Access Compliance Report

Public Rights-of-Way

Intersection ID: 10020275	Main Street: AYRSLEY_TOWN_BV	Cross Street: N/A	Location: NE
ADA ID: 9ED2168EE3FA	Ramp Type: BlendTrans2	Initial Pass/Fail: Pass	Overall Compliance: No
		Severity Score: 0.25

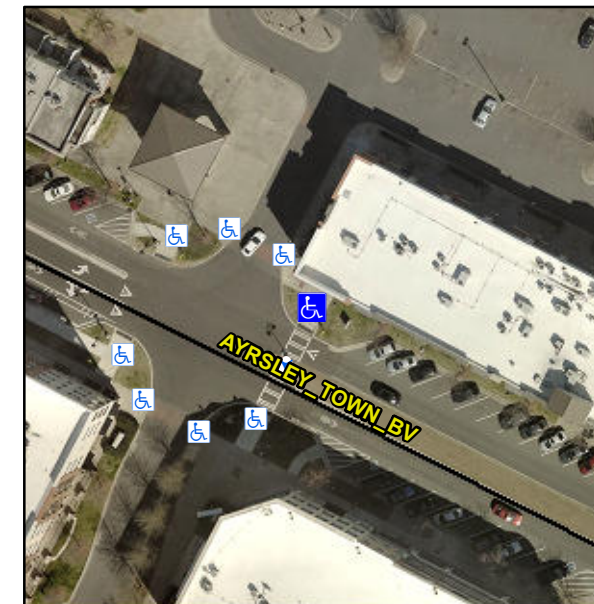
Surveyor Notes:

N/A

Not Found, R304.5.3, R305.2

Remove & Replace Curb Ramp With Two New Directional Ramps or Equivalent.
